**AGENDA
RED BANK ZONING BOARD OF ADJUSTMENT
OCTOBER 17, 2024**

**Re: Jersey Central Power and Light Company
160 East Newman Springs Road
Block 97, Lot 31
Application No. #24-P15743; Zone: LI
Preliminary and Final Major Site Plan
Second Engineering Review**

**Re: 196 Broad, LLC
Block 103, Lot 14 & 16, 196 Broad Street
Application No. #23-15454; Zone: PO & RA
Minor Subdivision & Site Plan
Second Engineering Review**

WOOD RISER POLE STRUCTURE #200
N.T.S.

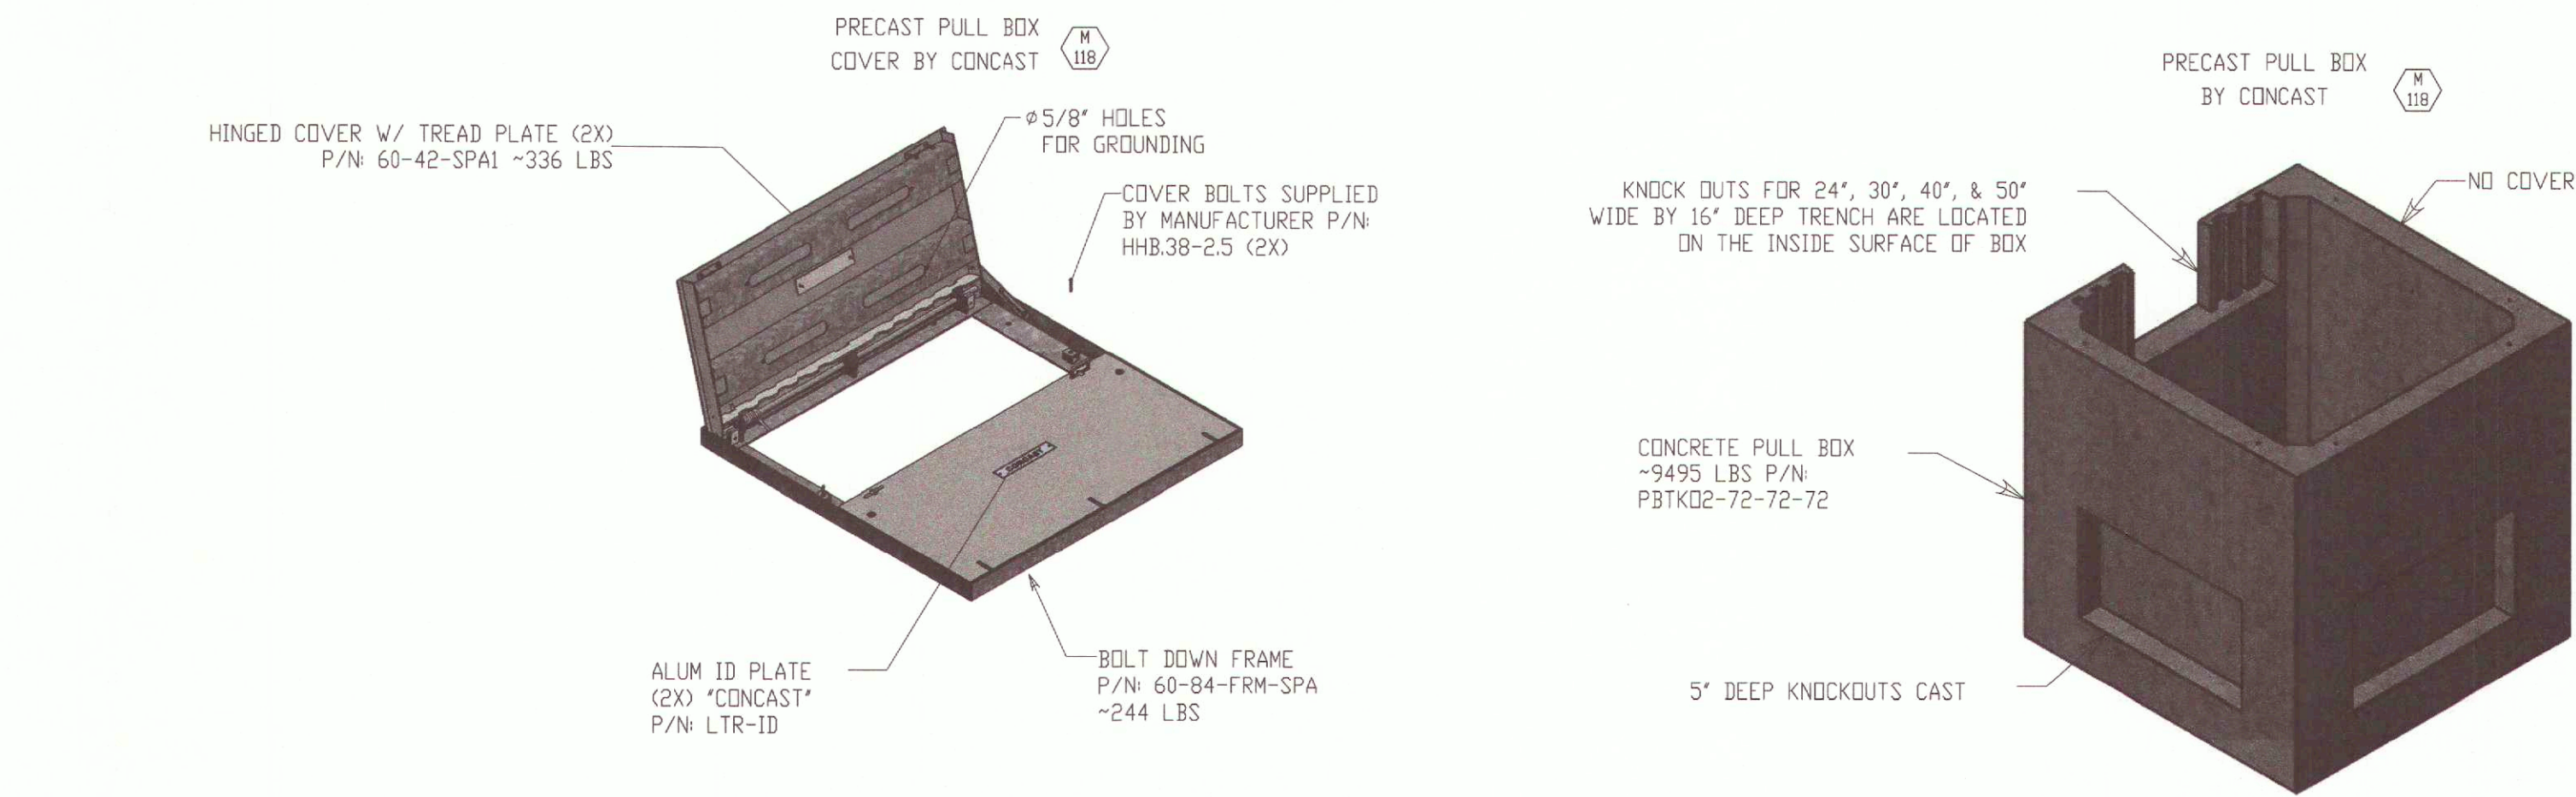
- b. Per §490-121.G, structures shall not encroach upon or unreasonably interfere with the use of public sidewalks or rights-of-way. A proposed riser-pole will slightly encroach within the Central Avenue right-of-way. It is this office's opinion that these improvements do not unreasonably interfere with the public sidewalk or right-of-way. **Continuing comment. It is this offices opinion that the application complies.**

- 2.1 The applicant proposes an underground transmission cable connection into a proposed rise pole in the R.O.W. **Continuing comment.**
- 2.2 We note during a site visit on July 26, 2024, Mohawk Lane was paved along the frontage of the substation. **Continuing comment.**
